# Illustrated Parts List - IPL Update

**365H**

## 1. Screw

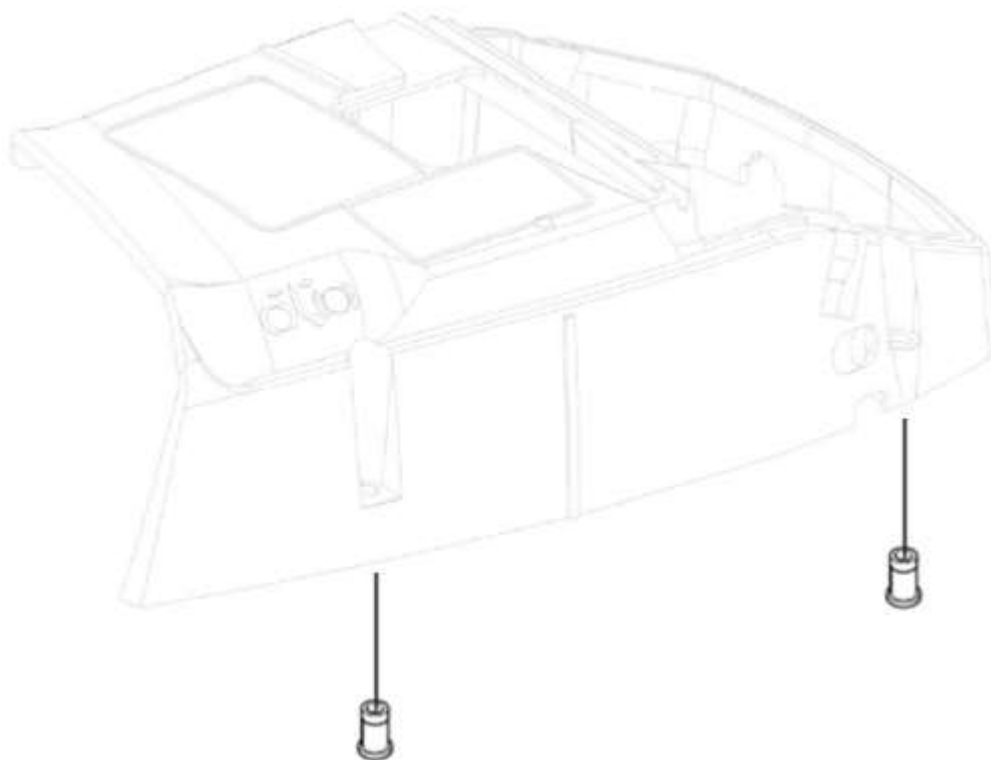
1. New screw with torx grip to cylinder cover provides better condition for tightening. Torx wrench added in tool kit.
2. New sleeve to cylinder cover. Available as separate spare part
3. New. Clutch with higher specification.
4. New reinforced recoil spring
5. Torx wrench T27/T20 available as spare part and also included in box

525 88 70-01

503 20 34-74
